Mulberry Court, Hampton Wick

RIBA Stage 4 Fire Strategy Report
Issue 03

APPENDIX 1 APPROVAL AUTHORITY (BUILDING CONTROL) COMMENTS AND RESPONSE (TO BE ACTIONED)

APPENDIX 2 APPROVAL AUTHORITY (LOCAL FIRE AUTHORITY) COMMENTS AND RESPONSE (TO BE ACTIONED)

Figure 8 - Escape corridor from Ground floor lobby

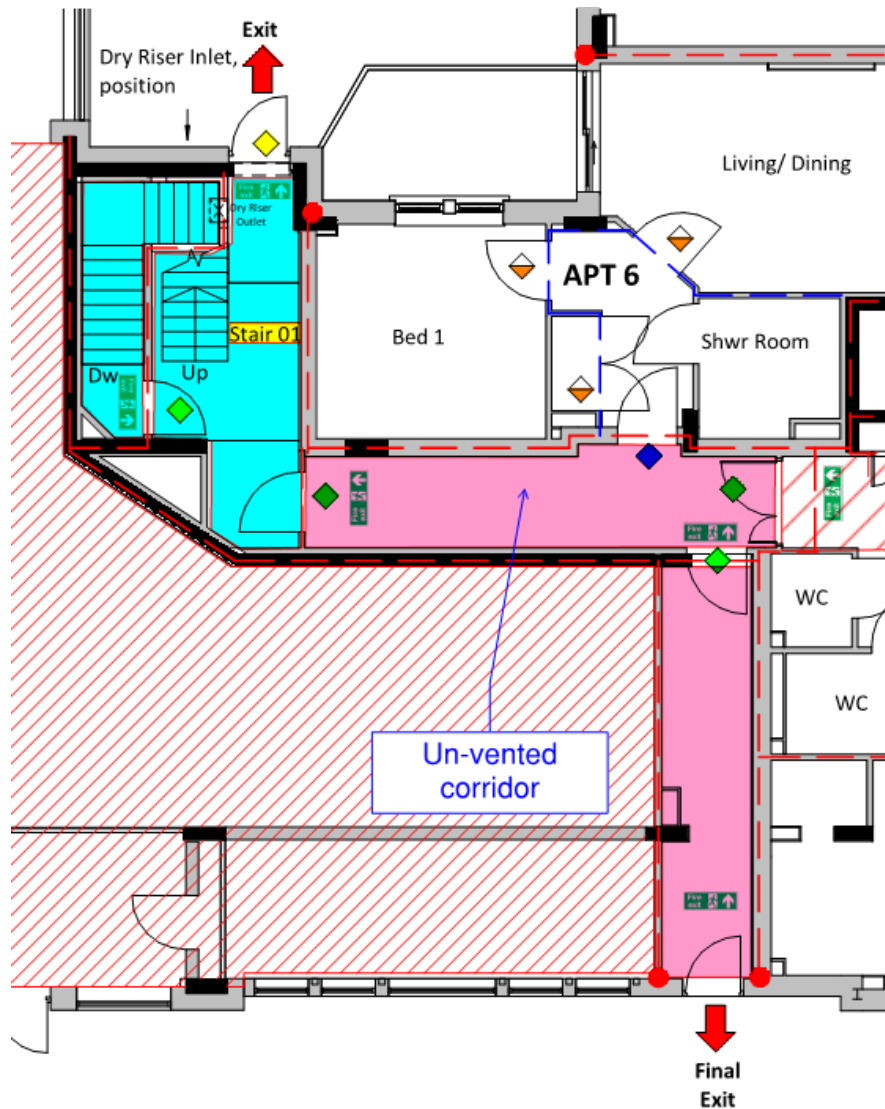
5. The curtain described in section 3.4.21 need careful consideration as to whether the proposals are sufficiently robust and can be managed and maintained. Failure of this curtain could allow smoke to spread onto other levels into unventilated areas of escape corridor. As the curtain is supporting the compartmentation within the building we question whether a smoke curtain alone is sufficient in this instance.

5. FDS - It is understood that the curtain reference in the FDS Consult Fire Strategy Section 3.4.21 has been omitted in lieu of 1hr fire Doors & Smoke seals (As Built Drawing C102-PRC-GF-DR-AR-30002-C04-PDF.pdf - dated 23/08/2021 refers).
